CDM Final Validation Report

CDM Validation

Incheon Metro Line 2

324169 / P32041.33

The conceptual project boundaries are given in figure 3 of the PDD:

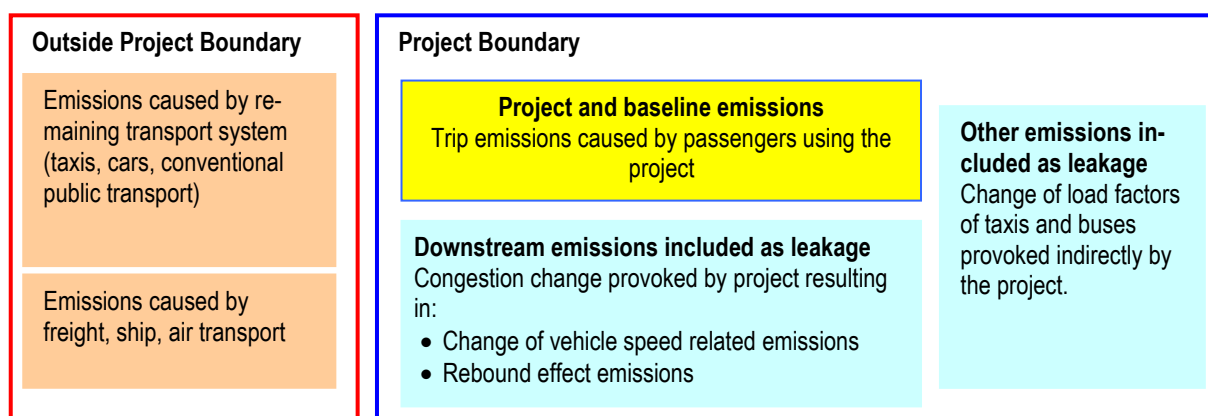
The spatial extent of the project according to the PDD is the SNCA, which corresponds to the methodology where the "LUZ larger urban zone" is mentioned. The spatial area includes the trip origins and destinations of passengers using the MRTS project line. The origins or destinations of these trips are not only located in Incheon Metropolitan City due not least to connecting metro lines with Seoul. Therefore, the larger spatial extent of the SNCA is taken.

According to the methodology version 2 a "larger urban zone (LUZ) of a city covers the whole functional zone around the city (including the core city) i.e. it corresponds to the commuting field around the city"; it is thus justified to speak of a larger urban zone for the cities Seoul, Bucheon and Incheon, but it was not clear to the validators what the relationship between "larger urban zones", "Seoul Metropolitan Area SMA" and "Seoul National Capital Area SNCA" is. Therefore, CL 4 was raised. This was clarified in Chapter A4.1.4 of the PDD. The local expert agreed with the explanation, therefore CL 4 could be closed.

No.:	CL 4	Reference:	PDD A 4.1.4
Validator request:	The context between a "larger urban zone LUZ", the "capital metropolitan area" is not defined clearly enough. See also CL 18.		
Project owner response:	Has been clarified in Chapter A.4.1.4 and made consistent between chapters.		
Validator conclusion:	Adaption OK, CL 4 closed.	Date:	12/04/2012

Figure 6: Baseline and Project Emissions

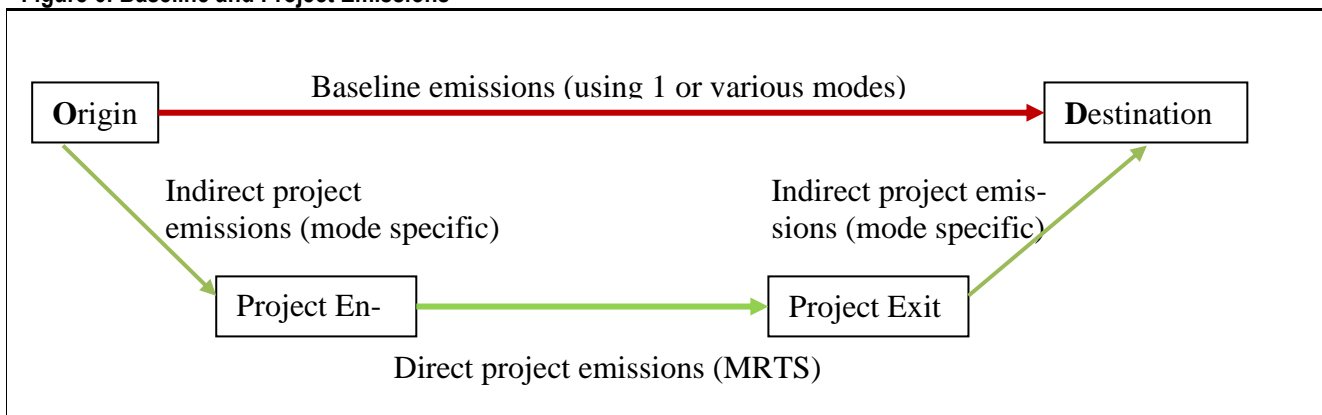
Figure 6 gives an overview of baseline and project emissions, the latter being differentiated in indirect and direct project emissions.

CL 11 was raised, since the site visit but also documents in the PDD revealed that the end of construction will be late 2014; so the first crediting period cannot start already in the beginning of 2014. The PDD was amended and the crediting period starts now on 01/01/2015.

No.:	CL 11	Reference:	PDD Annex 3
Validator request:	The end date of construction is mentioned as 18/11/2014. Why is the first crediting period already starting at the beginning of 2014?		
Project owner response:	Crediting period start is 01/01/2015		
Validator conclusion:	Tables with starting date 01/01/2015, OK, CL 11 closed.	Date:	12/04/2012
